Subject: Bid No. 7766-W2, Office Renovations – 50 Officer Manny Familia Way / DPF

ADDENDUM NO. 2

PROPOSED WASTE LINE CONECTION LOCATION

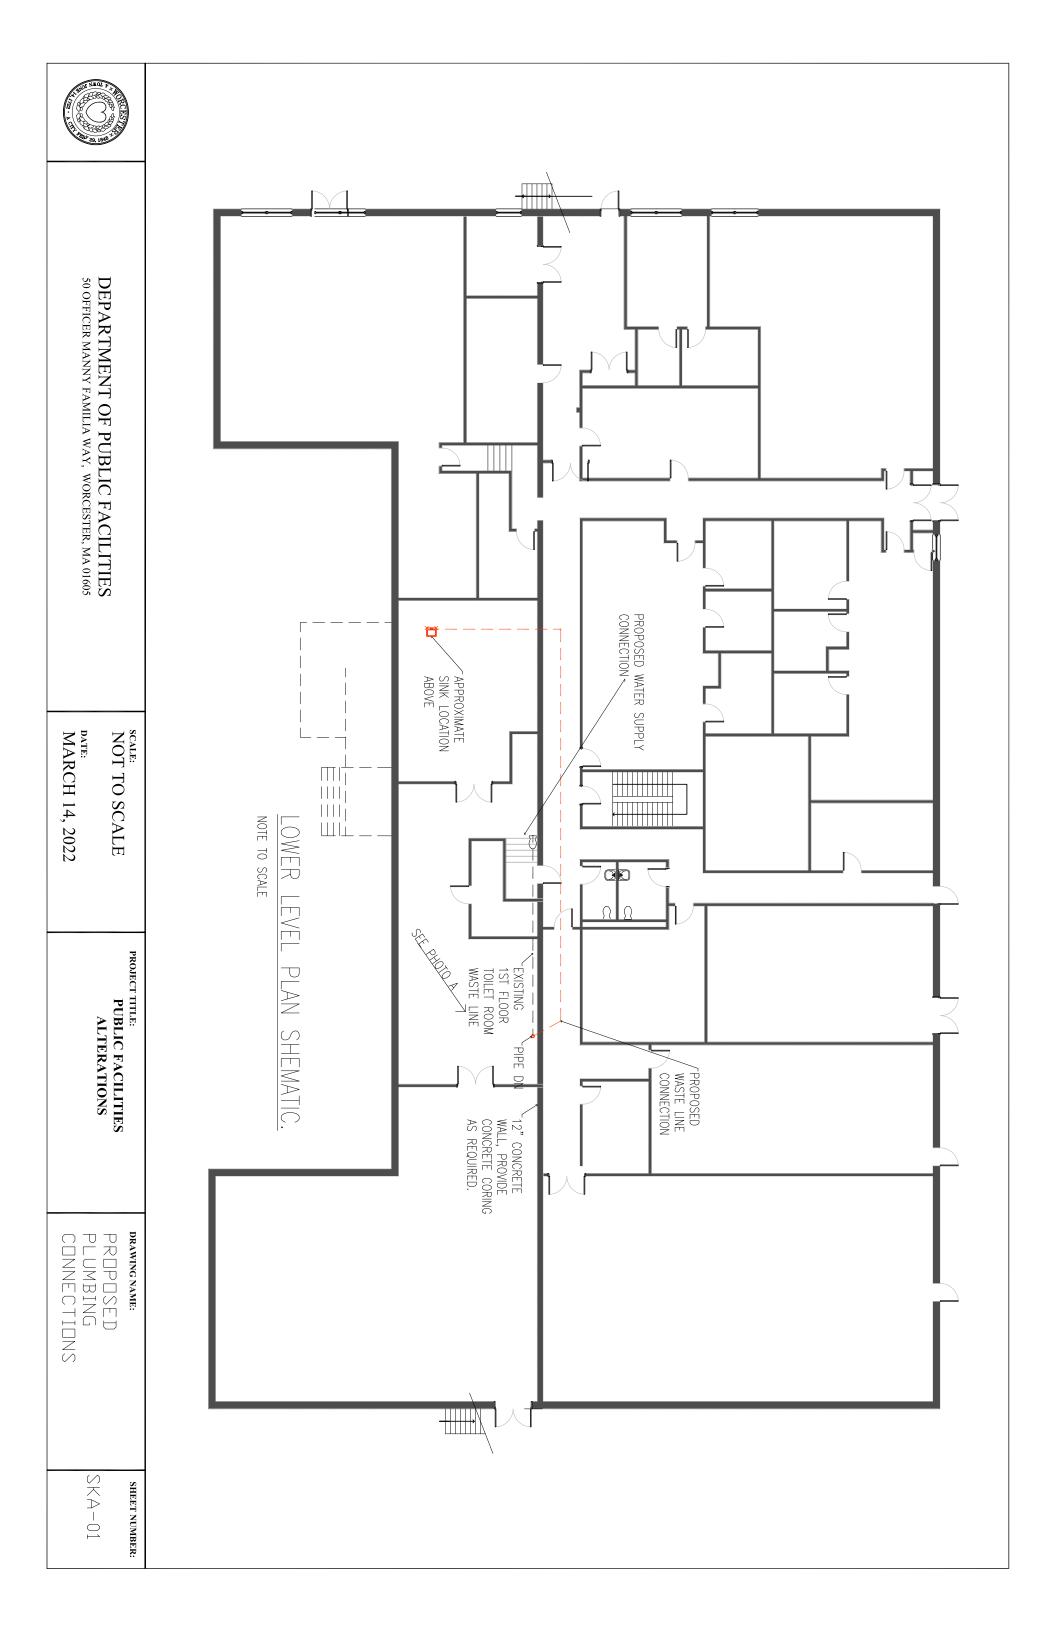
- 6. Relocate & terminate data drop in Conference & Break Room to above ceiling; patch wall.
- 7. Remove all existing carpet wall base.
- 8. See attached basement plan and photo for proposed lower level plumbing connection tie in's. Vent sink directly thru roof. Provide concrete coring and roof patching as required to maintain existing roof warranty.

1. <u>Question</u>: It appears that there is a sink in the Break Room, but I do not see any plumbing layout on the drawings. Is plumbing being done by the CoW or others?

Answer: Break Room sink and all plumbing and attachments to be provided by contractor, see attached SKA-01 and photo A for plumbing connections. Field verification of existing conditions for code compliant installation required by contractor. Abate ceiling tile and mastic and provide vent through roof at sink.
